DEVELOPMENT APPLICATION

APPLICATION NUMBER:	PLN-24-181
PROPOSED DEVELOPMENT:	Sediment Basin and associated works (Utilities)
LOCATION:	15 Redlands Drive Rosetta 2 Redlands Drive Rosetta
APPLICANT:	Glenorchy City Council
ADVERTISING START DATE:	09/05/2025
ADVERTISING EXPIRY DATE:	23/05/2025

Project: Glenorchy City Council - Redlands Drive, Rosetta Debris Basin	Project No.: 230352CS
---	-----------------------

PLN-24-290 RESPONSE TO ADDITIONAL INFORMATION REQUEST UNDER S54(1) LUPAA – REDLANDS DRIVE FLOOD EROSION MITIGATION WORKS

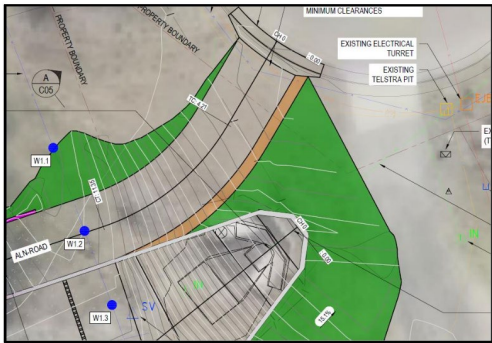
Clause 23.3.1 Discretionary use	Response:
<p>The submitted plan indicates the proposal may extend into the Environmental Management Zone (CT 50844/1) during construction, if this is the case then there may be an impact the land management values.</p> <p>Please demonstrate that the proposal satisfies performance criteria P1 of Clause 23.3.1 Discretionary use, Tasmanian Planning Scheme – Glenorchy. In particular, please demonstrate how the proposal will have regard to the protection, conservation and management of the site, and how the proposal will take measures to minimise or mitigate impacts.</p> <p>Note:</p> <p>If the construction area, including use of machinery, does not extend into CT 50844/1 please ignore this request.</p>	<p>Proposed works are to occur outside of the Environmental Management Zone. The Erosion and Sediment Control Plan provided indicates the separation of the proposed works to the shared boundary between 160921/1 and CT50844/1.</p>

Clause 23.4.1 Development area	Response:
<p>The submitted plan indicates the proposal may extend into the Environmental Management Zone (CT 50844/1) during construction, if this is the case then there may be an impact the land management values. Please demonstrate that the proposal satisfies performance criteria P1 of Clause 23.4.1 Discretionary use, Tasmanian Planning Scheme – Glenorchy. In particular, please demonstrate how the proposal will have regard to the protection, conservation, remediation or mitigation of the site.</p> <p>Note:</p> <p>If the construction area, including use of machinery, does not extend into CT 50844/1</p> <p>please ignore this request.</p>	<p>Proposed works are to occur outside of the Environmental Management Zone. The Erosion and Sediment Control Plan provided indicates the separation of the proposed works to the shared boundary between 160921/1 and CT50844/1.</p>

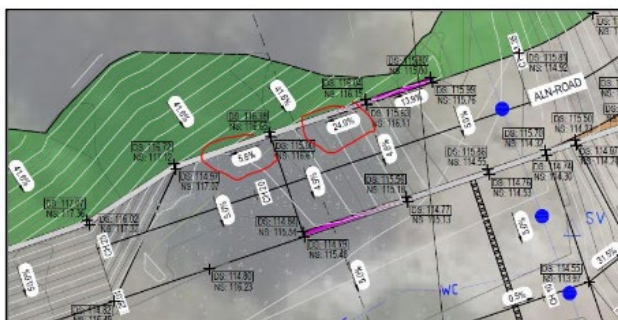
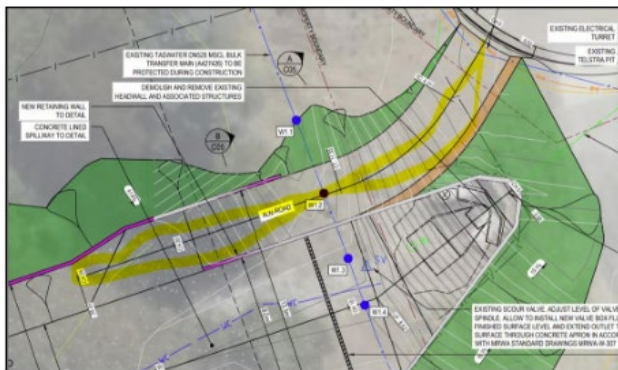
C2.6.2 Design and layout of parking areas	Response

Layout of driveway and parking areas must be in accordance with the AS2890.1:2004 (depends what kind of vehicle is going to use the driveway) and the Scheme requirements. Please clearly show on the parking plan details of the proposed driveway, access and parking areas including gradients, parking area, spot levels, manoeuvring area, materials, finishing surface and drainage details must be submitted to demonstrate compliance and shall comply with the followings:

- Please show driveway long section CH00-CH25 to demonstrate the design is in accordance with AS. It is noted that the grades exceed 25% maximum allowable grade.
- Show detailed driveway crossover including footpath width, wings and grade.

<p>area, particularly around the mouth of the pipes. The ability to use a vac truck provides an alternative method of debris removal without requiring additional modifications to the driveway grade.</p> <ul style="list-style-type: none"> • A 30% longitudinal grade remains within acceptable parameters for maintenance vehicles and personnel access. Many utility and maintenance roads exceed standard residential driveway requirements and still function effectively for their intended purpose. Given that this driveway is not intended for frequent or daily passenger vehicle use, but rather periodic maintenance access, a steeper grade is reasonable and practical. • The presence of heavy equipment such as backhoes and excavators ensure that any required maintenance, including clearing debris, silt, and other obstructions, can be effectively conducted without the need for a lower-grade driveway. The use of specialised equipment mitigates the need for compliance with residential driveway slope standards. Additionally, the driveway has been designed to only need to be cleaned quarterly, meaning access will be required only once every three months.
